ENGINEER'S GRADING AND DRAINAGE CERTIFICATION FOR TEMPORARY CERTIFICATE OF OCCUPANCY

ENGINEER'S GRADING CERTIFICATION

ALBUQUERQUE SAFE CO.

GRADING PLAN
ALBUQUERQUE SAFE CO.

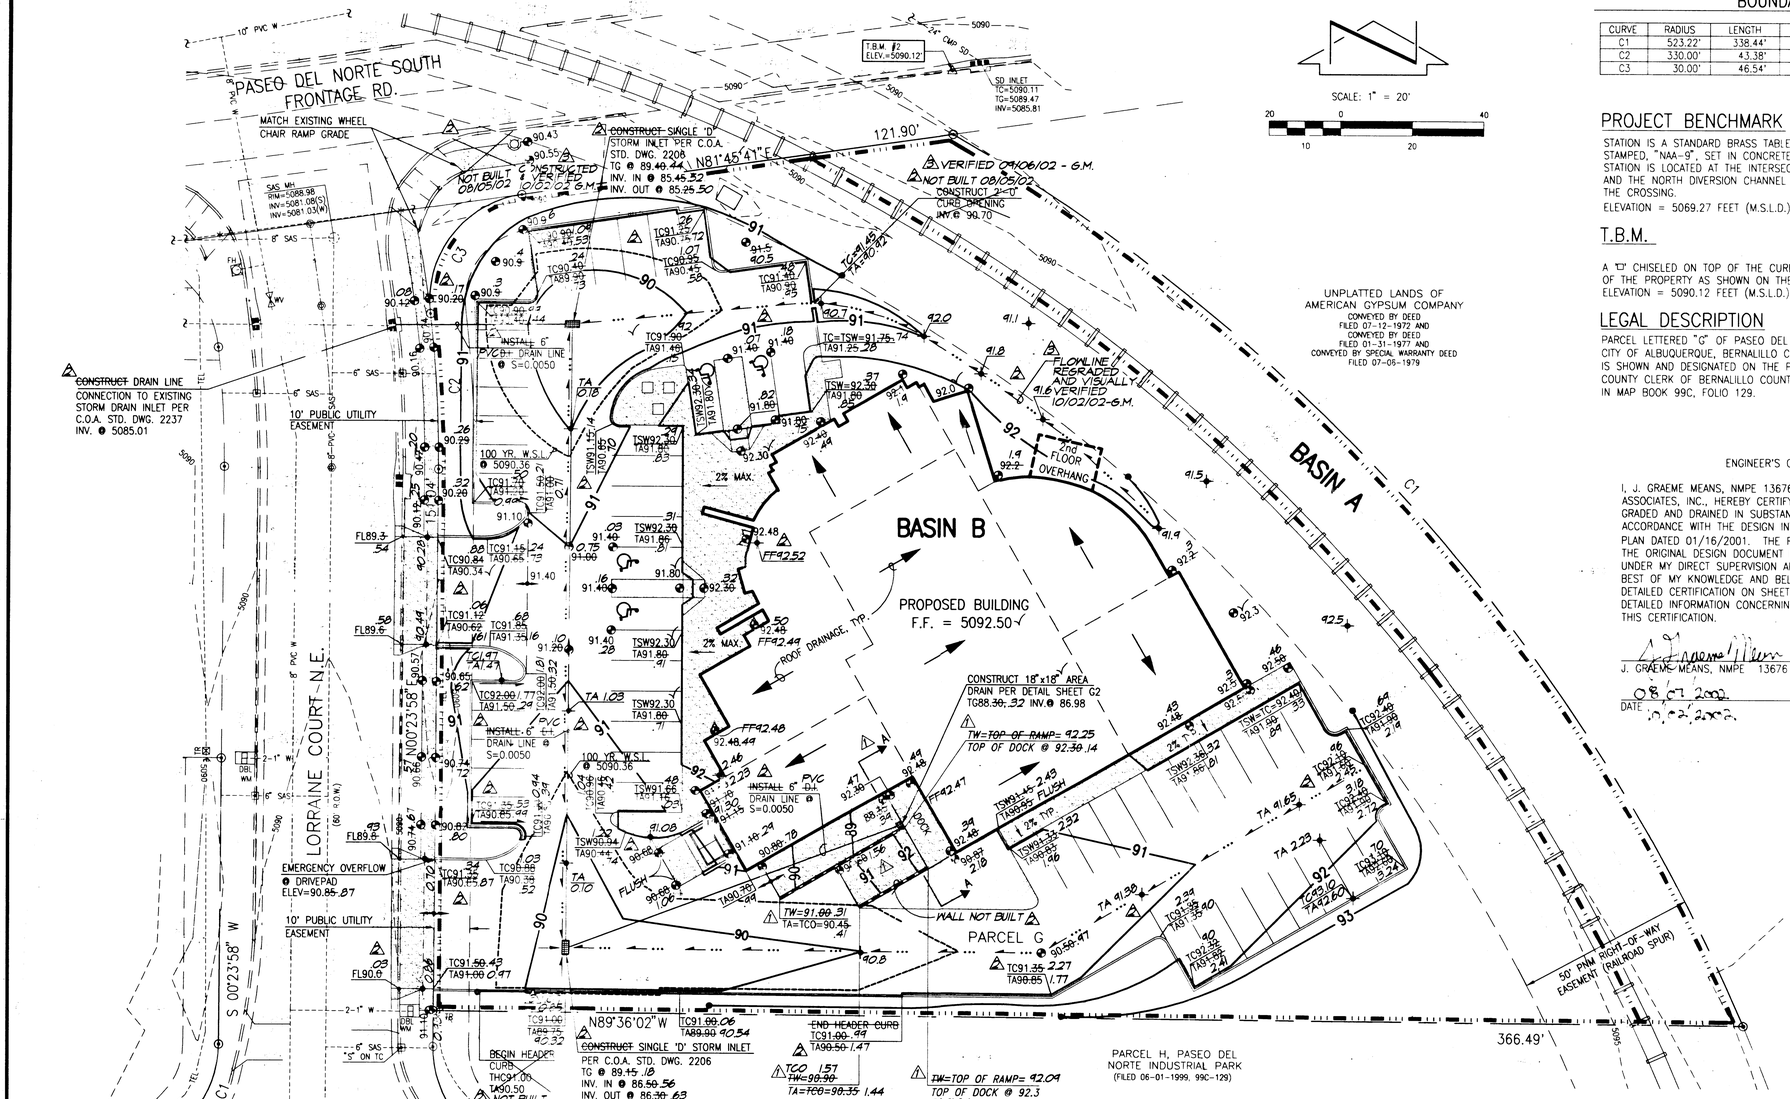
1) THE 6" PRIVATE STORM DRAIN LINES WERE SPECIFIED AS DUCTILE IRON PIPE AND WERE CONSTRUCTED AS PVC. THIS DEVIATION HAS NO ADVERSE EFFECT ON PIPE CAPACITY, BUT THE OWNER MAY EXPERIENCE ADDITIONAL MAINTENANCE AND A REDUCED LIFE CYCLE FOR THE PIPE DUE TO THE ANTICIPATED REPEATED HEAVY TRUCK LOADS.

2) THE GRADES AROUND THE PAVED DETENTION POND SURROUNDING THE SOUTHERNMOST STORM INLET WERE CONSTRUCTED SIGNIFICANTLY HIGHER THAN THOSE ON THE DRB APPROVED PLAN RESULTING IN A 50% REDUCTION IN POND CAPACITY. FORTUNATELY, THE ORIGINAL POND DESIGN WAS CONSERVATIVE AND THE AS-CONSTRUCTED POND VOLUME SATISFIES THE INTENT OF THE APPROVED PLAN AND DOES NOT REQUIRE REMOVAL AND REPLACEMENT OF THE PAVEMENT TO PROVIDE ADDITIONAL CAPACITY.

1) THE CONTRACTOR DID NOT CONSTRUCT THE GRADED FLOWLINE AROUND THE EAST AND NORTH SIDES OF THE BUILDING AS SHOWN ON THE DRB APPROVED PLAN. THIS FLOWLINE WAS REQUIRED BY THE BN&SF RAILROAD TO PREVENT DEVELOPED RUNOFF FROM ENTERING THE RAIL SPUR EASEMENT. THIS FLOWLINE MUST BE CONSTRUCTED IN ACCORDANCE WITH THE APPROVED PLAN AND RE-CERTIFIED.

2) THE CONTRACTOR DID NOT CONSTRUCT THE CURB OPENING AT THE NORTHEAST CORNER OF THE PARKING LOT SHOWN ON THE DRB APPROVED PLAN TO ACCEPT DRAINAGE FROM THE AFOREMENTIONED FLOWLINE. THIS OPENING MUST BE CONSTRUCTED IN ACCORDANCE WITH THE APPROVED PLAN AND RE-CERTIFIED.

3) THE CONTRACTOR DID NOT CONSTRUCT THE HEADER CURB SPECIFIED ALONG THE SOUTH EDGE OF THE PAVEMENT RESULTING IN THE POTENTIAL FOR POND OVERFLOW TO THE PRIVATE PROPERTY TO THE SOUTH INSTEAD OF TO THE PUBLIC STREET TO THE WEST. THE SOUTH CURB MUST BE CONSTRUCTED IN ACCORDANCE WITH THE APPROVED PLAN AND RE-CERTIFIED.

4) THE PRIVATE STORM DRAIN CONNECTION TO THE EXISTING CITY INLET AT THE NORTHWEST CORNER OF THE SITE REQUIRED AN S.O.19 PERMIT AND CITY INSPECTION. A SIGNED COPY OF THE CITY INSPECTOR'S APPROVAL MUST BE PROVIDED PRIOR TO RE-CERTIFICATION.

1) THE GRADED FLOWLINE AROUND THE EAST AND NORTH SIDES OF THE BUILDING HAS BEEN CONSTRUCTED AND A STEEL LANDSCAPING EDGE HAS BEEN PROVIDED TO FURTHER PREVENT RUNOFF FROM ENTERING THE RAIL SPUR EASEMENT.
2) THE CURB OPENING AT THE NORTHEAST CORNER OF THE PARKING LOT HAS BEEN CONSTRUCTED.
3) THE SOUTH CURB HAS BEEN RAISED TO THE MINIMUM REQUIRED ELEVATION AND NOW SATISFIES THE INTENT OF THE APPROVED PLAN.
4) THE PRIVATE STORM DRAIN CONNECTION AT THE NORTHWEST CORNER OF THE SITE REQUIRED AN S.O.19 PERMIT AND CITY INSPECTION. A SIGNED COPY OF THE CITY INSPECTOR'S APPROVAL IS PROVIDED HEREWITH.

SITE PLAN / TRAFFIC CIRCULATION LAYOUT (TCL)
ALBUQUERQUE SAFE CO.

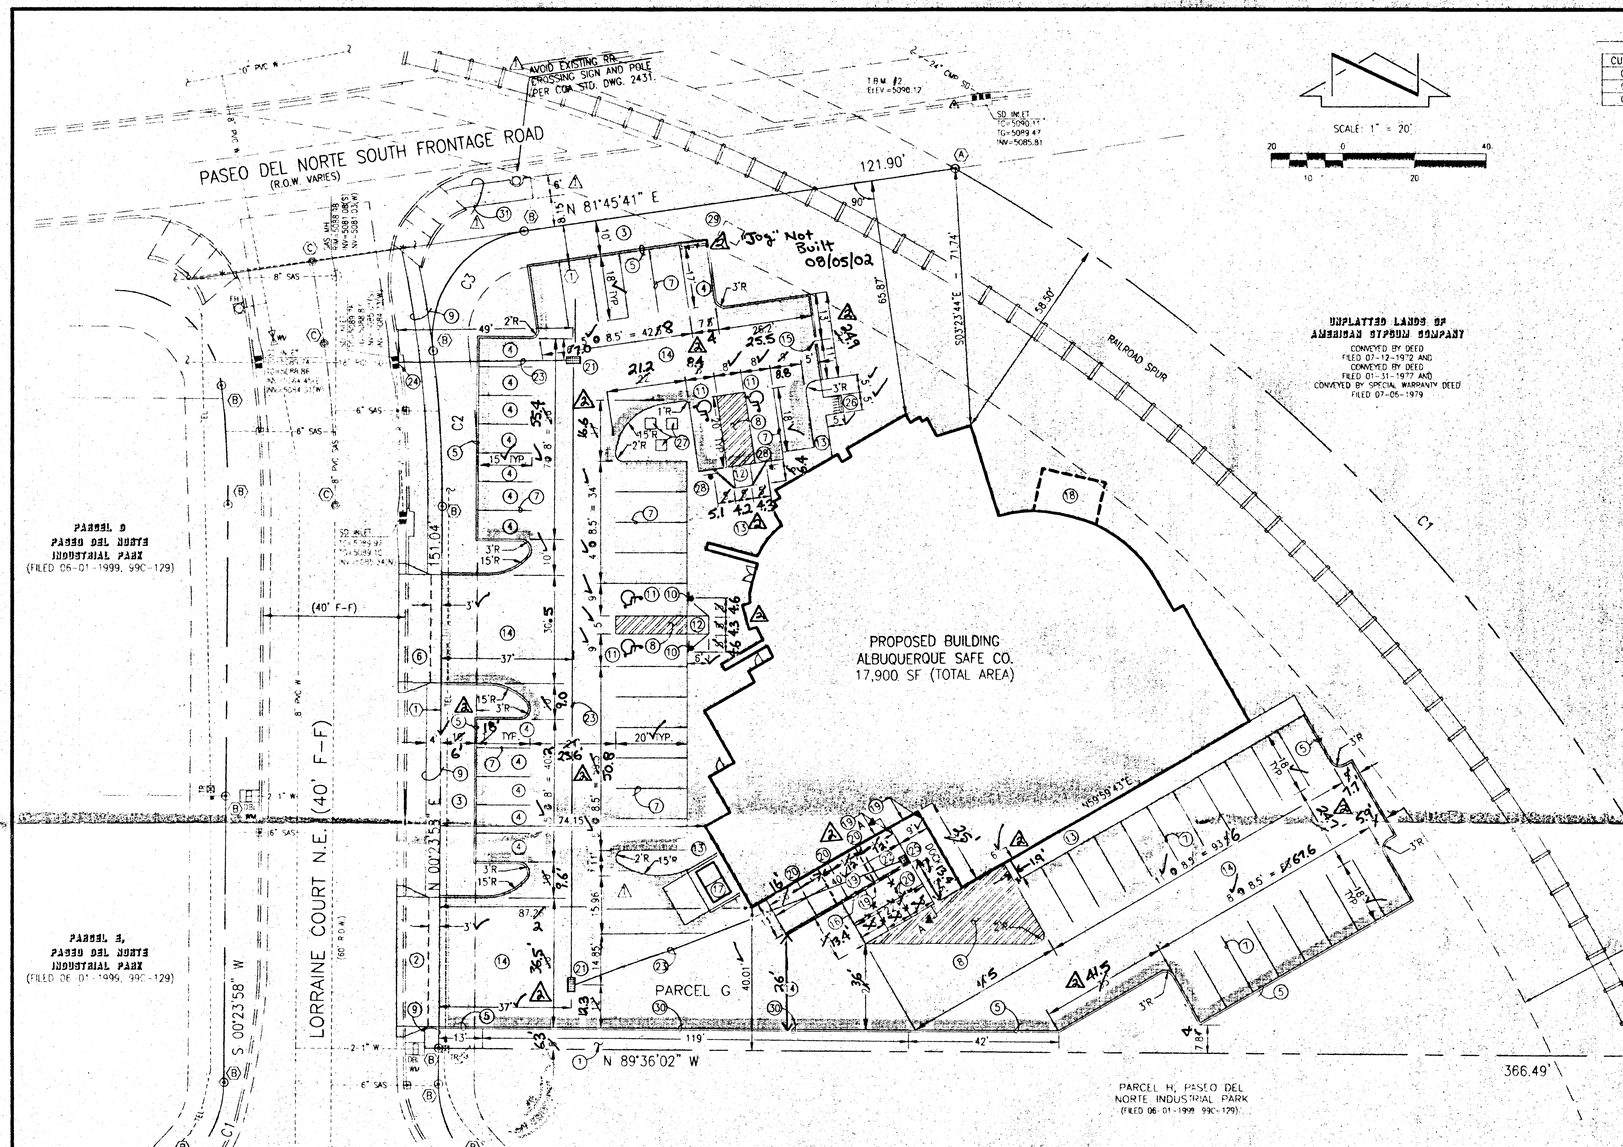
1) THE CONTRACTOR DID NOT CONSTRUCT THE "JOG" IN THE CURB AT THE NORTHEAST CORNER OF THE PARKING LOT. THIS JOG WAS INTENDED TO AVOID A POTENTIAL ENCROACHMENT INTO THE EXISTING RAIL SPUR EASEMENT. THIS DEVIATION HAS NO ADVERSE EFFECT ON TRAFFIC CIRCULATION AND EVALUATION OF THIS POTENTIAL ENCROACHMENT IS BEYOND THE SCOPE OF THIS CERTIFICATION.

2) THE CONTRACTOR DID NOT CONSTRUCT THE 2'-0" CURB OPENING (KEYED NOTE 15) AT THE EAST END OF THE DRIVE AISLE KEYWAY NORTH OF THE BUILDING. THIS DEVIATION HAS NO ADVERSE EFFECT ON TRAFFIC CIRCULATION, AND WILL BE ADDRESSED BY THE GRADING AND DRAINAGE CERTIFICATION TO BE PREPARED BY THIS OFFICE.

3) THE CONTRACTOR DID NOT CONSTRUCT THE CONCRETE HEADER CURB (KEYED NOTE 30) ALONG THE SOUTHERN EDGE OF THE SITE AND INSTALLED EXTRUDED CURB IN ITS PLACE. THIS DEVIATION HAS NO ADVERSE EFFECT ON TRAFFIC CIRCULATION, AND WILL BE ADDRESSED BY THE GRADING AND DRAINAGE CERTIFICATION TO BE PREPARED BY THIS OFFICE.

4) THE 6" PRIVATE STORM DRAIN LINES WERE SPECIFIED AS DUCTILE IRON PIPE AND WERE CONSTRUCTED AS PVC. THIS DEVIATION HAS NO ADVERSE EFFECT ON TRAFFIC CIRCULATION, BUT THE OWNER MAY EXPERIENCE ADDITIONAL MAINTENANCE AND A REDUCED LIFE CYCLE FOR THE PIPE DUE TO THE ANTICIPATED REPEATED HEAVY TRUCK LOADS.

1) THE CONTRACTOR DID NOT CONSTRUCT THE PIECE OF 6' WIDE CONCRETE SIDEWALK FRONTING EL PUEBLO ROAD (KEYED NOTE 31). THIS SIDEWALK MUST BE CONSTRUCTED IN ACCORDANCE WITH THE DRB APPROVED PLAN.

2) THE CONTRACTOR DID NOT INSTALL THE "SMALL CAR" STENCILING (KEYED NOTE 4) IN THE SMALL CAR SPACES. THESE MARKINGS MUST BE INSTALLED IN ACCORDANCE WITH THE DRB APPROVED PLAN.

3) THE CONTRACTOR CONSTRUCTED THE SMALL CAR PARKING SPACES BETWEEN THE TWO DRIVEPADS 18' DEEP INSTEAD OF 15' DEEP AS SHOWN ON THE DRB APPROVED PLAN. THIS DEVIATION RESULTS IN PARKING SPACES WITH FULL SIZED DEPTH AND SMALL CAR WIDTH AND MUST BE CORRECTED TO CONFORM WITH THE DRB APPROVED PLAN. THE ADDITIONAL PARKING SPACE DEPTH PROVIDED SUBTRACTS FROM THE LANDSCAPING BUFFER DEPTH WHICH WAS SPECIFIED AS 10' AND CONSTRUCTED AS 6', POTENTIALLY CAUSING A ZONING VIOLATION.

4) THE CONTRACTOR HAS CONSTRUCTED THE ACCESSIBLE PARKING SPACES NORTH AND WEST OF THE BUILDING AT SLOPES VARYING BETWEEN 2.9% AND 4% WHICH EXCEED THE MAXIMUM 2% SLOPE IDENTIFIED IN A.D.A. GUIDELINES AND SPECIFIED ON THE DRB APPROVED PLAN. THESE SPACES MUST BE CORRECTED TO CONFORM WITH A.D.A. GUIDELINES.

(1) 6' SIDEYARD LANDSCAPING BUFFER
(2) CONSTRUCT ADA COMPLIANT 36" CONCRETE DRIVEPAD PER C.O.A. STD. DWG. 2425.
(3) 6' FRONTYARD LANDSCAPING BUFFER
(4) STENCIL "COMPACT CAR" OR "SMALL CAR" DESIGNATION WITH WHITE PAINTED LETTERING. ~~Not Done 08/05/2002~~

(14) CONSTRUCT NEW ASPHALT PAVING PER TYPICAL PAVEMENT SECTION, SHEET 2.
(15) ~~2'-0" CURB OPENING~~ Not Built 08/05/2002
(16) RETAINING WALL WITH HANDRAIL PER SECTION A-A, SHEET 2.

(29) EXISTING RAILROAD CROSSING CONTROL BUILDING.
(30) CONSTRUCT CONCRETE HEADER CURB (PER TYPICAL SECTION SHEET 2)
(31) CONSTRUCT 6' WIDE CONCRETE SIDEWALK PER C.O.A. STD. DWG. 2430. TERMINATE SIDEWALK WITH SQUARED END AT EDGE OF RIGHT-OF-WAY EASEMENT. ~~Not Built 08/05/2002~~

TYPICAL HEADER CURB SECTION

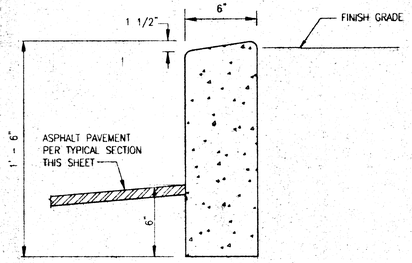
⚠2 Not Built 08/05/02
